Access Compliance Report Public Rights-of-Way (Curb Ramps)

Intersection ID: 18821 Main Street: ARBOR_WY Cross Street: SHARON_LN Location: S

ADA ID: BFCE795AD572 Ramp Type: PerpDiag Initial Pass/Fail: Fail Overall Compliance: No Severity Score: 13.75

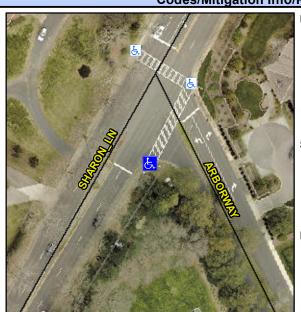
Not Found, R304.2.2, R304.5.3

Compliance Description Data		Compliance Description		Data	
N/A	Ramp Length (in)	60.0	No	Ramp Slope (%)	8.6
Yes	Ramp Width (in)	48.0	No	Ramp XSlope (%)	4.1
N/A	Flare Type LT	N/A	N/A	Flare Type RT	N/A
N/A	Flare Slope LT (%)	N/A	N/A	Flare Slope RT (%)	N/A
N/A	Flare Traversable LT?	N/A	N/A	Flare Traversable RT?	N/A
N/A	Landing Length (in)	N/A	N/A	DWS Provided?	N/A
N/A	Landing Width (in)	N/A	N/A	DWS Contrast?	N/A
N/A	Landing Slope (%)	N/A	N/A	DWS Length (in)	N/A
N/A	Landing X Slope (%)	N/A	N/A	DWS Full Width?	N/A
N/A	Landing Curb? (Y/N)	N/A	N/A	DWS Offset (in)	N/A
N/A	Shared Landing?	N/A			
N/A	Gutter Ponding?	N/A	N/A	Gutter Slope (%)	N/A
N/A	Gutter Lip Ht (in)	N/A	N/A	Gutter X Slope (%)	N/A
N/A	Painted X Walk1?	Yes	N/A	Painted X Walk2?	No
	X Walk 1 Direction	To NE		X Walk 2 Direction	To NW
N/A	X Walk 1 Width (in)	112.0	N/A	X Walk 2 Width (in)	N/A
	X Walk 1 Slope (%)	3.0		X Walk 2 Slope (%)	3.2
	X Walk 1 X Slope (%)	3.3		X Walk 2 X Slope (%)	1.7

Remove & Replace Curb Ramp With Two New Directional Ramps or Equivalent.
